**Before the Panel Convener appointed under the
Fast-track Approvals Act 2024**

In the matter of Mt Welcome, Pukerua Bay

By Pukerua Property Group Limited Partnership

Response to Panel Minute 2

Figure 3: Potential Future East West Roding connections (taken from page 16 of Appendix 8 to the Substantive Application)

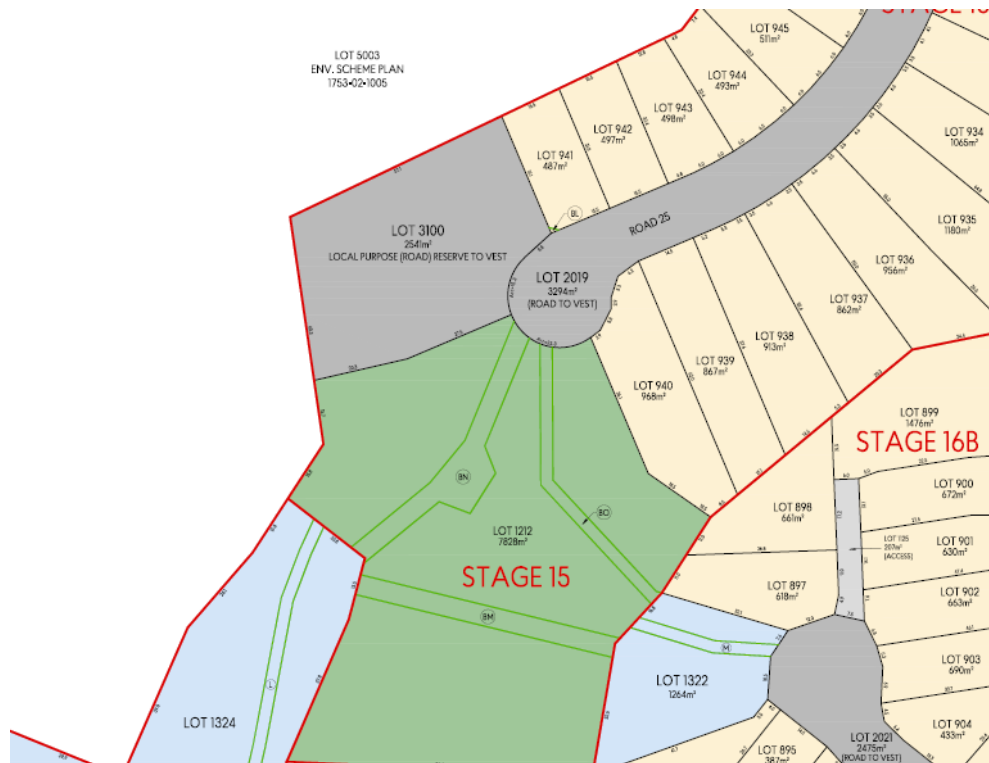
- 39 As outlined in Appendix 8 to the Substantive Application, there is only one west/east roading connection in the proposed development rather than two shown in the Structure Plan in the area shown in purple in Figure 2 below. There is no proposed roading connection as indicated below in red. The Applicant does not own the land where this indicative road is located. Lot 5003 will be retained by the Mount Welcome Block Trust for continued farming use. If this landowner wished to subdivide in the future, they too would be subject to the Structure Plan provisions in the District Plan.
